Issue date:	Place:	Page:	Ident.
05.02.2019	Akland, Norway	1 of 1	HSE-2019-01

This document applies to:		Internal use:	External use:	X
This HSE Bulletin applies to:		HSE Subject:		
WTD	X	Broken spring cause malfunction of Water Tight Door (WTD)		
SAFETY WINDOWS				
AUTOMATION				
Updated by:		VML		
Authorized by technical manager:		BNI		
Approved by managing director:		RLA

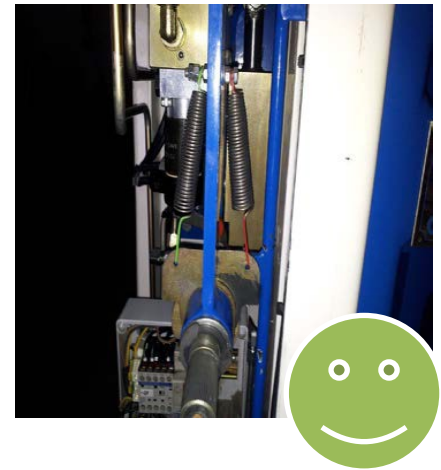
Operating doors at high frequency may cause the springs for operation handle to break. Broken spring can cause the handle to go to closing position unintended. This is a critical situation regards to personal safety. The watertight door will then act as it is in remotely closed position. According to SOLAS, the watertight doors shall only be in remote closed mode in emergency situation or for testing purposes. Modified broken springs, unoriginal springs, and neglecting the replacing of springs are seen frequently.

WRONG TYPE

WRONG TYPE

CORRECT TYPE

- Replace old (every 40,000 operations or every year) springs with new design springs to improve life time and proper working watertight doors.
- Replace both springs annually and simultaneously.
- Do not modify the springs, or modify broken springs.
- Use only original and certified springs.

IMS has performed a design improvement to improve the life time of the springs. Each spring is colored red or green and packed individually. Each spring is marked with certified heat number. Part numbers for the new springs are: 10000346 (spring, door open) & 10000347 (spring, door close). See IMS user manual for watertight doors for correct installation of springs.
